Department of Transportation

MEMORANDUM

SUBJECT: ZC Case No. 19-09 – 1650 Kenilworth Avenue NE (Kenilworth Assisted Living)

Figure 1 – Site Plan (Source: Grove/Slade, 5/21/19 CTR, Figure 8)

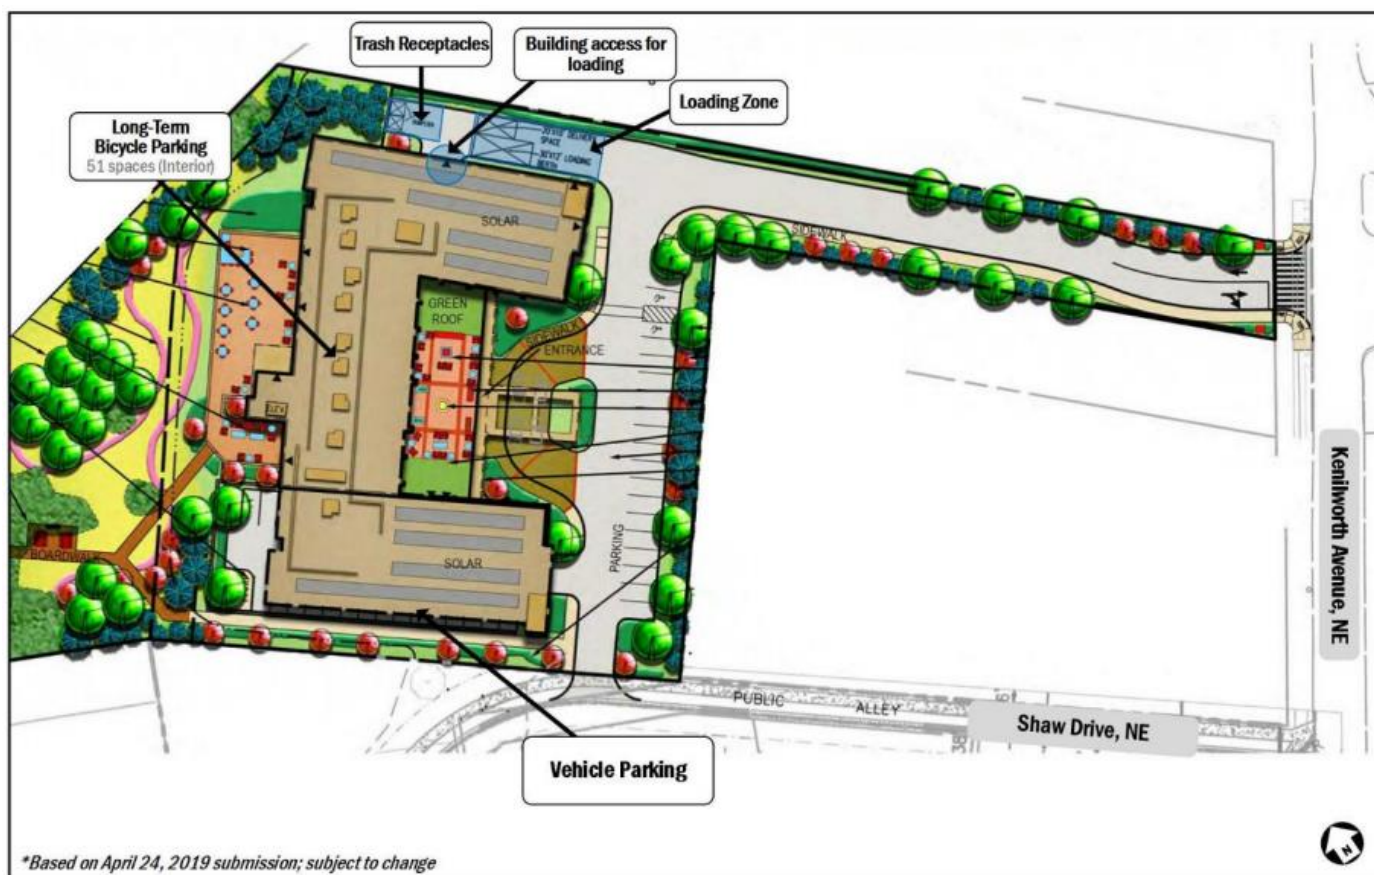
- The curb cut to Kenilworth Avenue should be a maximum of 24-feet wide (currently shown as 28-feet), have a maximum of 15-foot curb radii, be at-grade with the existing street, and include pedestrian curb ramps and a crosswalk across the new intersection leg;

- The curb radii for the connection to the alley to the south (Shaw Drive NE) should be reduced from 15-feet to 6-feet;
- Typically, short-term bicycle parking racks are installed in public space. However, given the minimal amount of public space touching the site, the Applicant should install them on private property and follow the design requirements of ZR16 Subtitle C § 804. They should be moved from the garage and rear of the building to near the front door;

Note: The Applicant is revising the site plan to no longer show the connection to the existing alley in the near-term.

- The curb cut to Kenilworth Avenue should be a maximum of 24-feet wide (currently shown as 28-feet), have a maximum of 15-foot curb radii, be at-grade with the existing street, and include pedestrian curb ramps and a crosswalk across the new intersection leg;
- The curb radii for the driveway to Shaw Drive NE should be reduced from 15-feet to 6-feet; and
- Typically, short-term bicycle parking racks are installed in public space. However, given the minimal amount of public space touching the site, the Applicant should install them on private property and follow the design requirements of ZR16 Subtitle C § 804. They should be moved from the rear of the building and parking garage to near the front door.

Figure 2 – Eastern Avenue ROW Comparison (Source: Gorove/Slade)

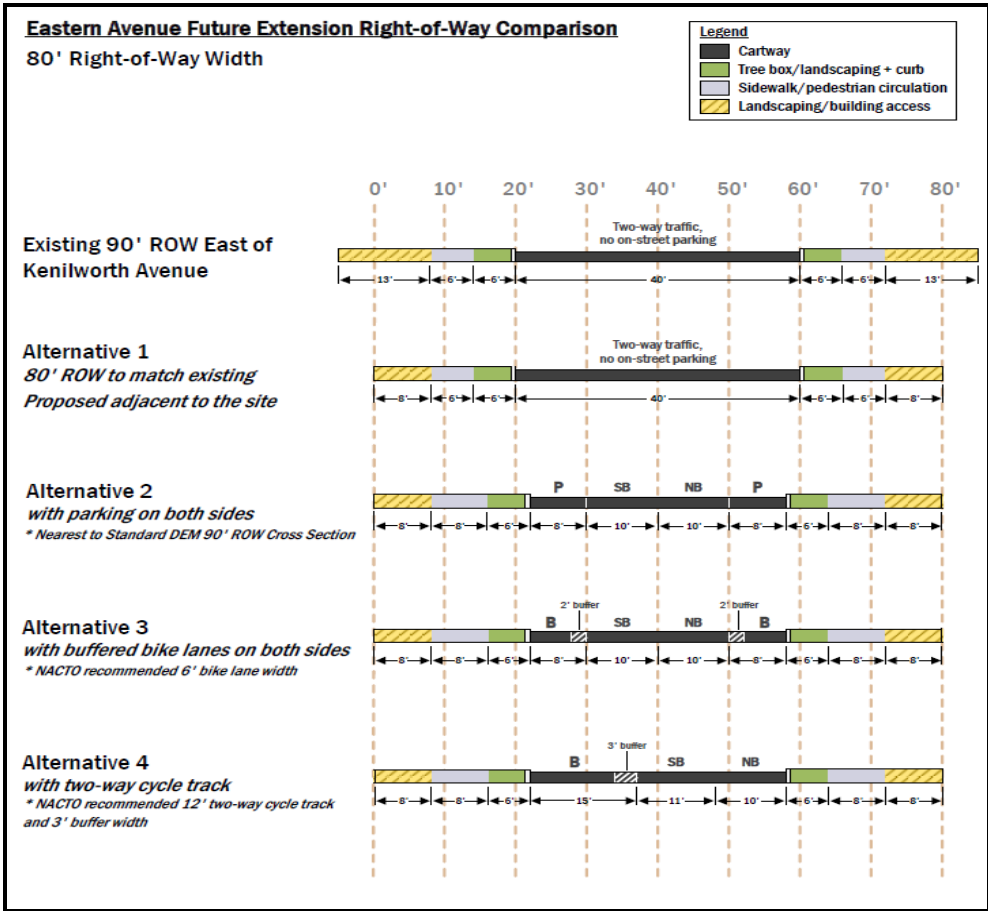
East of Kenilworth Avenue, the existing section of Eastern Avenue is four-lane undivided within a 90-foot right of way, as measured from the Maryland State Line. The Applicant has sufficiently demonstrated a hardship with accommodating 90-feet of right-of-way and has proposed an alternative 80-foot section (see Figure 2 below). Given the environmental constraints with developing the site, DDOT finds the Applicant’s proposal for an 80-foot right-of-way section of Eastern Avenue west of Kenilworth Avenue acceptable. An 80-foot section will still allow DDOT to provide four-lanes of traffic with pedestrian facilities which matches the existing section. It also allows for flexibility in the roadway cross-section to accommodate bicycle facilities, fewer travel lanes, and/or additional green space.

Figure 3 – Eastern Avenue ROW to be Dedicated (Source: Grove/Slade)

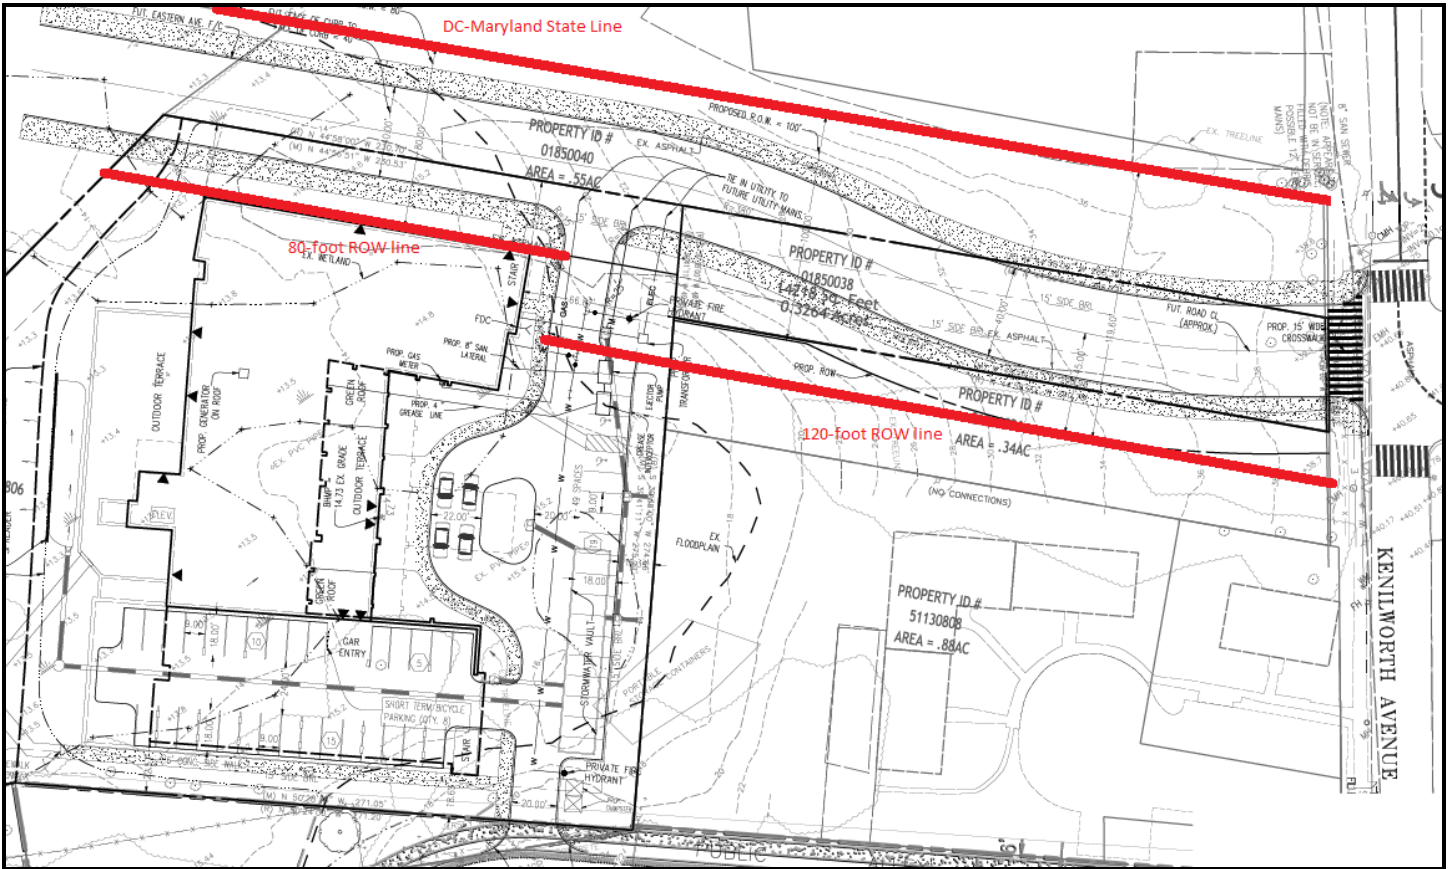
- A maximum of 120-feet of right-of-way may be needed close to the intersection with Kenilworth Avenue to straighten out the Eastern Avenue extension since the bridge over the Anacostia Freeway (MD 295) is skewed from the original alignment (see Figure 3 in this report); and

As shown in Figure 3 below, more right-of-way (upwards of 120-feet) will likely be needed closer to the intersection with Kenilworth Avenue to straighten out the Eastern Avenue extension since the bridge over the Anacostia Freeway (MD 295) is skewed from the original alignment.

The Applicant must commit to dedicating 120 feet of right-of-way near the intersection and 80-feet along the northern side of the assisted living building to accommodate future Eastern Avenue. The dedication must be at no cost to the District and at the time of the District’s choosing. In the meantime, the property will stay under the Applicant’s ownership and no building structures will be allowed to be built in this area. Since there are several other land owners in the vicinity of the site, the Applicant will only be responsible for dedicating the portions of right-of-way that are under their control. The Applicant should also dedicate, at no cost to the District and at the timing of the District’s choosing, any right-of-way necessary along the back side or in the northwest corner of the site that DDOT may need to extend Anacostia Avenue to Kenilworth Avenue.
